PCN-20200330 TE0630-02 SPI Flash Change

Company	Trenz Electronic GmbH
PCN Number	PCN-20200330
Title	TE0630-02 SPI Flash Change
Subject	BOM change
Issue Date	2020-04-06

This change affects all Trenz Electronic TE0630 SoMs of revision 02: TE0630-02*.

Locate Flash (U14) on bottom side of PCB:

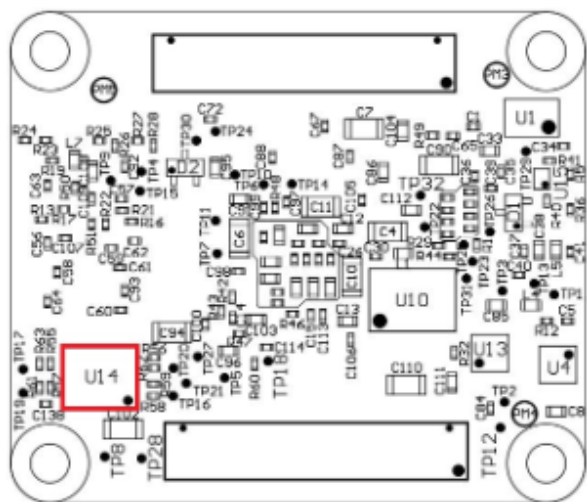
#1 Change SPI Flash from W25Q64FVZPIG to W25Q64JVZPIQ

Reason: W25Q64FVZPIG SPI Flash is obsolete.

Impact: None. Both have same JEDEC ID 9Fh and manufacturer ID 90h.

old	new
W25Q64FVZPIG	W25Q64JVZPIQ
